Access Compliance Report Public Rights-of-Way (Curb Ramps)

Main Street: ARADA_ST Cross Street: AIROSO_ST Location: NE

ADA ID: RPAT211104113657 Ramp Type: Type 1 - Perpendicular Diagonal Initial Pass/Fail: Fail Overall Compliance: No Severity Score: 15

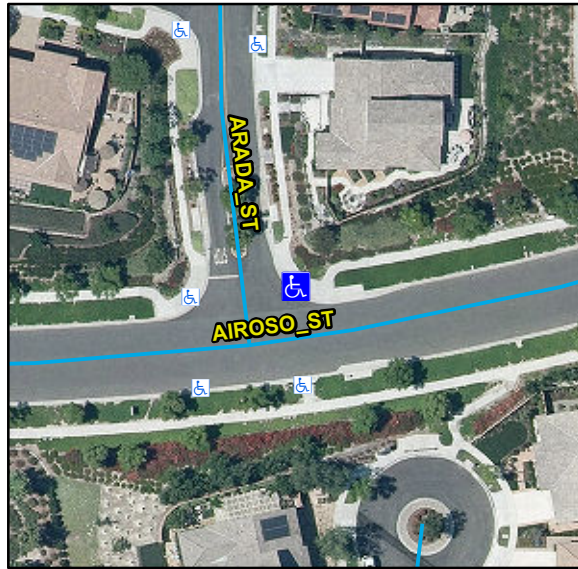
Compliance	Description	Data	Compliance	Description	Data
N/A	Ramp Length (in)	37	N/A	Flare Type LT	
Yes	Ramp Width (in)	48			N/A
Yes	Ramp Run Slope (%)	6.9	N/A	Flare Slope LT (%)	N/A
No	Ramp Cross Slope (%)	6.4	N/A	Flare Traversable LT	N/A
N/A	Landing Present	N/A	N/A	Flare Type RT	
N/A	Landing Length (in)	N/A			N/A
N/A	Landing Width (in)	N/A	N/A	Flare Slope RT (%)	N/A
N/A	Landing Run Slope (%)	N/A	N/A	Flare Traversable RT	N/A
N/A	Landing Cross Slope (%)	N/A	N/A	DWS Provided	N/A
N/A	Landing Movement Obstructed?	N/A	N/A	DWS Contrast	N/A
	Landing Movement Type	N/A	N/A	DWS Length (in)	N/A
N/A	Landing Shared	N/A	N/A	DWS Full Width	N/A
N/A	Clear Space	Yes	N/A	DWS Offset Left (in)	N/A
N/A	Clear Space To Crosswalk (in)	N/A	N/A	DWS Offset Right (in)	N/A
N/A	Marked Crosswalk 1	No	N/A	Marked Crosswalk 2	No
	Crossing 1 Direction	W		Crossing 2 Direction	S
	Marked Crosswalk 1 Width (in)	N/A		Marked Crosswalk 2 Width (in)	N/A

N/A	Ramp Inside Crosswalk 1	N/A	Yes	Ramp Inside Crosswalk 2	N/A
	Crossing 1 Slope (%)	8.6		Crossing 2 Slope (%)	0.2
	Crossing 1 Cross Slope (%)	1.2		Crossing 2 Cross Slope (%)	9.2
N/A	Gutter Ponding	N/A	N/A	Curb Slope	4.6
Yes	Gutter Lip Height (in)	0		Road Run Slope (%)	6.9
N/A	Gutter Run Slope (%)	N/A		Road Cross Slope (%)	6.7
N/A	Gutter Cross Slope (%)	N/A			
Yes	Overall Surface Condition: Acceptable		Yes	Perp Joint Present	Yes
	Cross Gutter Present?	No		Spandrel Present?	No
	Replace Cross Gutter?	N/A		Replace Spandrel?	N/A

Remove & Replace Curb Ramp With Two New Directional Ramps or Equivalent.
